Prairie Island Nuclear Generating Plant  
1717 Wakonade Drive East  
Welch, MN 55089

Prairie Island Nuclear Generating Plant's Fifth Six-Month Status Report in Response to March 12, 2012 Commission Order Modifying Licenses with Regard to Requirements for Reliable Spent Fuel Pool Instrumentation (Order Number EA-12-051) (TAC Nos. MF0832 and MF0833)

### **Prairie Island Nuclear Generating Plant, Units 1 and 2 Fifth Six-Month Status Report for Implementation of Order EA-12-051, Order Modifying Licenses with Regard to Requirements for Reliable Spent Fuel Pool Instrumentation**

### **Prairie Island Nuclear Generating Plant, Units 1 and 2 Completion of Required Action by NRC Order EA-12-051 Reliable Spent Fuel Pool Instrumentation**

Figure 1 – Locations of SFPI Equipment

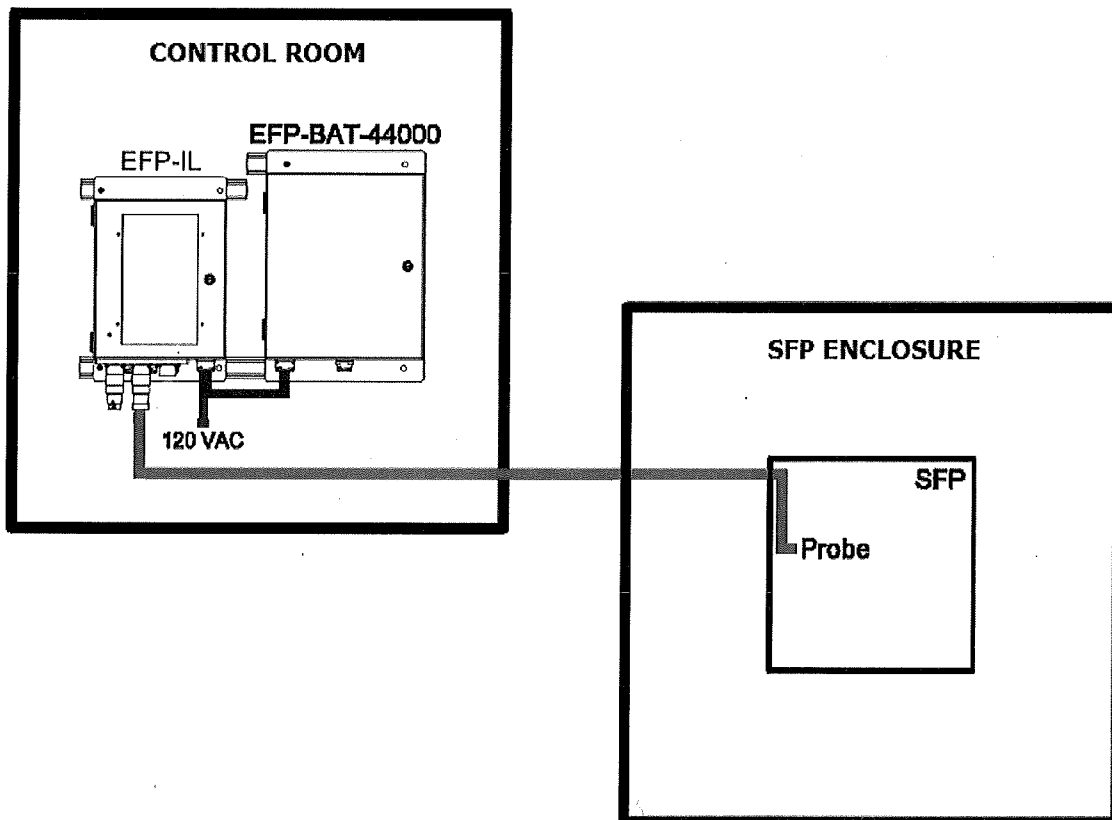
**Please provide a clearly labeled sketch or marked-up plant drawing of the plan view of the SFP area, depicting the proposed routing of the cables that will extend from the sensors toward the location of the read-out/display device.**

**Please provide additional information describing how the final arrangement of the SFP instrumentation and routing of the cabling between the level instruments, the electronics and the displays, meets the Order requirement to arrange the SFP level instrument channels in a manner that provides reasonable protection of the level indication function against missiles that may result from damage to the structure over the SFP.**

NSPM has installed a fixed probe in each of the two connected spent fuel storage pools at PINGP. The probes are mounted in the northwest corner of SFP #1 and in the northeast corner of SFP #2. Both the primary and backup displays are located in the control room. The primary SFPI cable routing from the SFP #2 to the Unit 1 Control Room uses existing penetrations and cable trays. The backup SFPI cable routing from the SFP #1 to Unit 2 Control Room uses existing embedded conduits, penetrations and cable tray system. Cable for each channel is routed in separate conduits and cable trays to provide additional redundancy.

As discussed in the response to RAI 4, the SFP level probes are mounted in the northwest corner of SFP #1 and in the northeast corner of SFP #2. This arrangement provides separation of the probes by a distance that is greater than the longest length of a side of the larger of the two connected pools. The NEI guidance provides that separation by a distance comparable to the shortest length of a side of the pool is acceptable. This arrangement also uses the inherent protection provided by the pool walls. Additionally, the entire spent fuel pool at PINGP is enclosed in a Class 1 structure designed to protect the pool from tornado generated missiles. Therefore, the location and arrangement of probes meets the NEI 12-02 guidance.

Cables for each channel are routed in separate conduits and cable trays to provide separation, which meets the NEI 12-02 arrangement guidance for missile protection. The displays are located in the Control Room, which is missile protected.
